City of Richmond
Urban Development Division

**Report to
Development Permit Panel**

To: Development Permit Panel
From: Joe Erceg
Manager, Development Applications
Date: August 7, 2003
File: DP 03-237856
Re: **Application by Fairchild Developments Ltd. for a Development Permit at
8060 Cambie Road**

3 ACCESSIBLE HOTEL UNIT 1
SCALE: 1/8" = 1'-0"

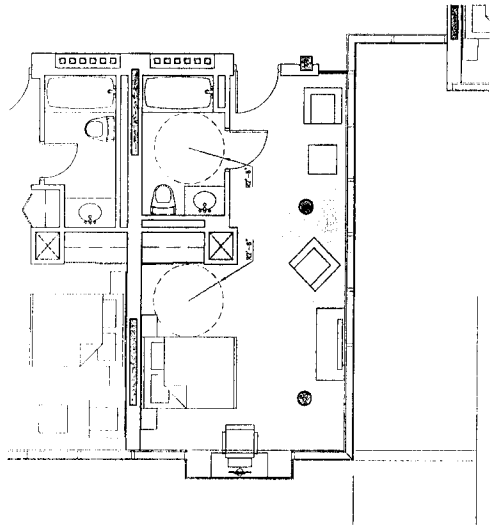
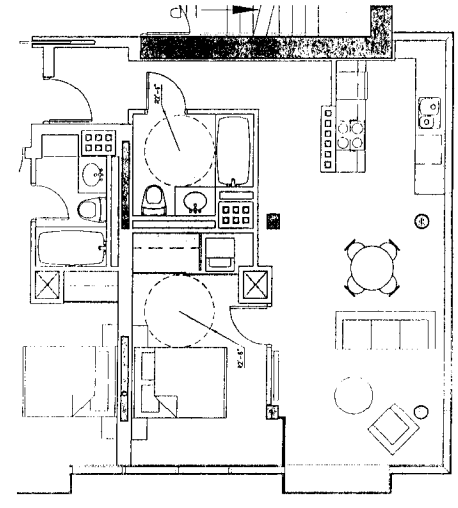
Show typical hotel rooms designed for disabled access. *Plans have been provided.*

- It was questioned whether the four (4) accessible rooms required by code would be one unit type or scattered throughout the building.
- An impressive project. The ceiling heights were of concern, especially those of the hallways. The model was somewhat misleading – the project could turn out to be a big grey box.”

- several locations for green roofs would be considered.
- the accessible units would be scattered throughout the building.
- the P4 level entrance from the parkade was reviewed as was the proposed link from the second level of the mall.

2 NORTH ELEVATION

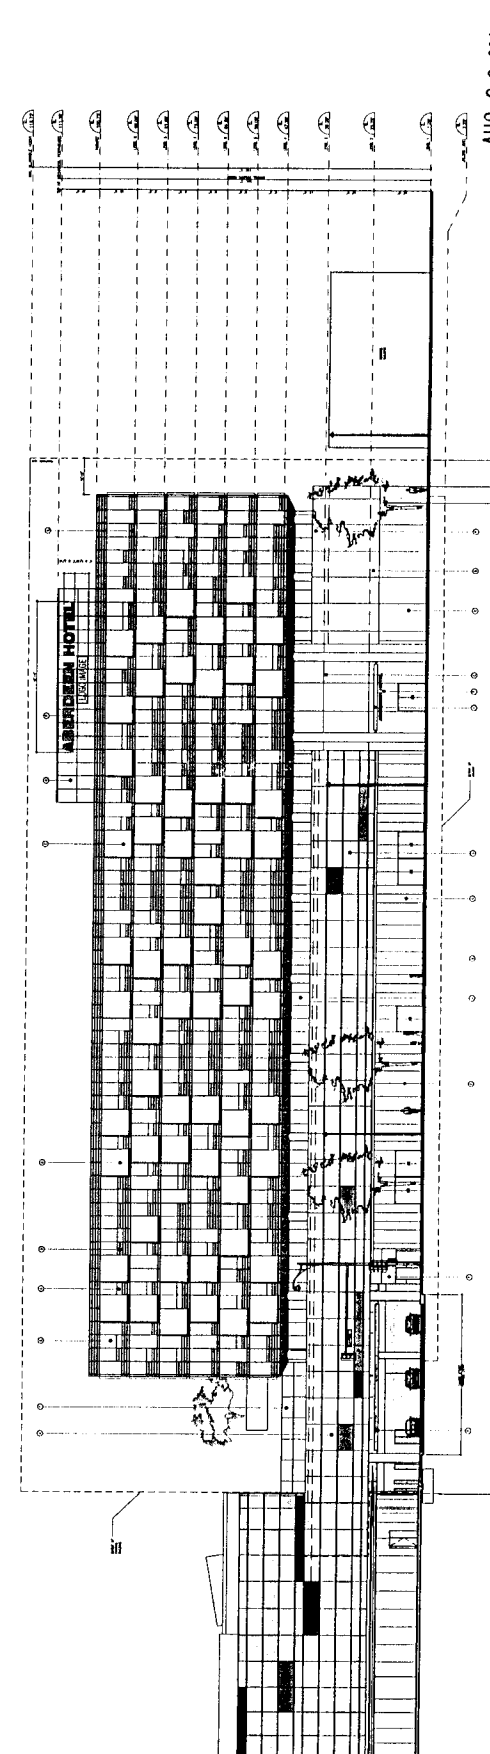
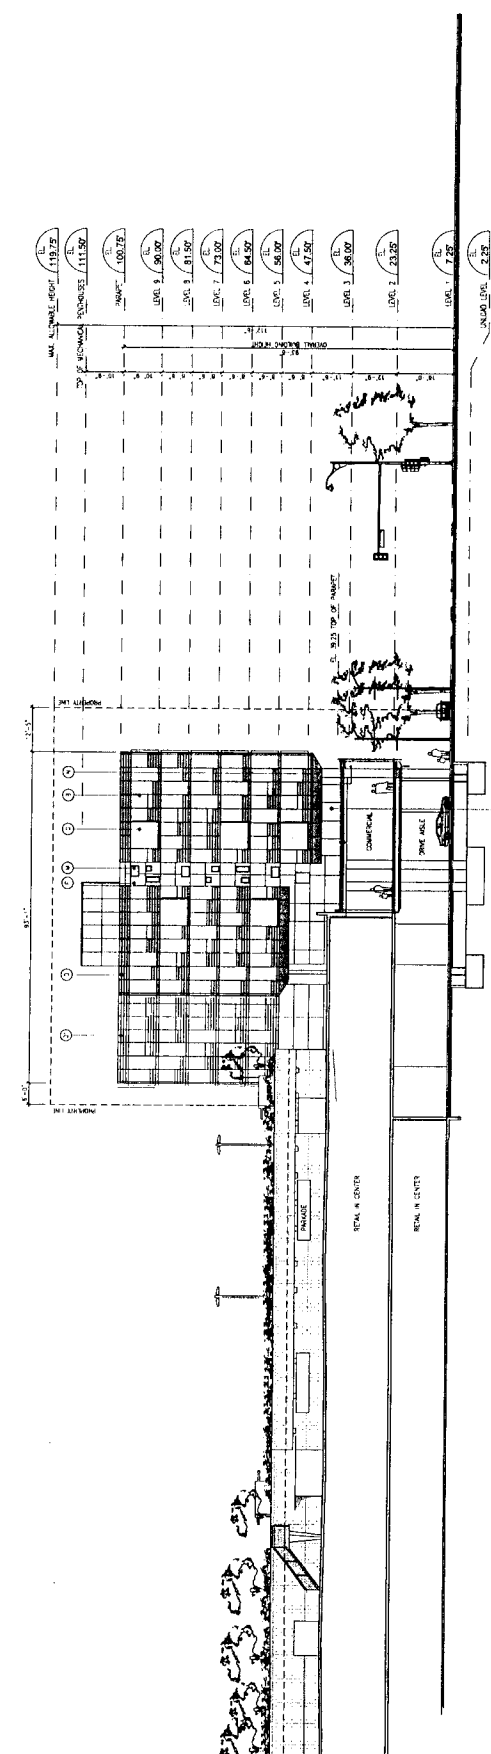
1. Is the building setback to the line of the furthest projection of the north facade? The canopy at the entrance to the hotel is within 1 or 2 feet of the property line.
2. Portions of the suites facing the south property line appear to encroach on the 6 ft. setback.
3. Code issues will be forwarded to the architect's office.
4. As the allowable and provided Floor Area Ratio (F.A.R.) for the project is at a maximum, it would be interesting to see what was and was not included in the calculations.
5. Assure that the transformer does not block exiting from the building (show dimension between the transformer and the building.) Will a blast wall be required? Perhaps the transformer should be inside the building.

The only variance required is for the canopy over the hotel entry. The transformer is dimensioned and will have sufficient clearance.

2. ROOF PLAN
SCALE: 1/8" = 1'-0"

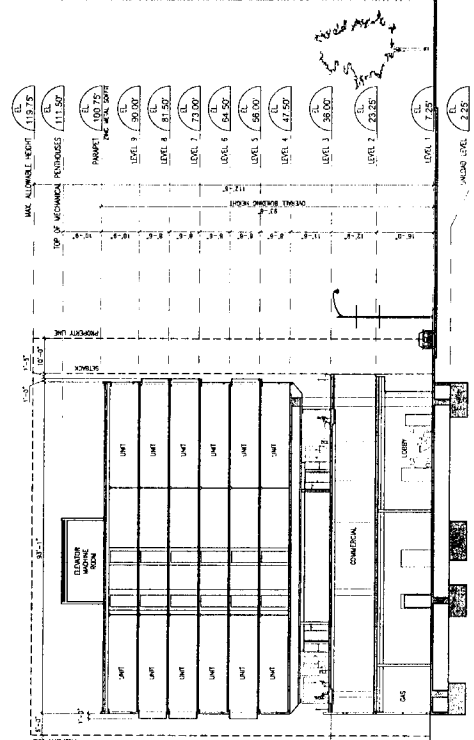
The applicants have added landscaping to the decks at the second level. They do not want to add a green roof on top of the hotel because it might increase the load on the foundations. The statistics, dimensions and parking garage information has been added to the plans. The developers have agreed to convey title of the Community Amenity Space to the City. The applicants will liaise with the school board regarding the School Site Acquisition levy. If necessary, the developer could enter into a covenant specifying that the strata-titled units may not be used for residential purposes or a School Site Levy will be required. The developer has requested that a new letter of credit not be required, but that the existing letter of credit for the mall be retained until final inspection of the hotel landscaping. This is acceptable to staff.

- A striking project that blended well to the site. The lack of green space was of concern – the building would lend itself to greening of some of the roof areas, including the main roof. If not utilized as green space, other sustainable practices were recommended, such as water retention, for these areas.
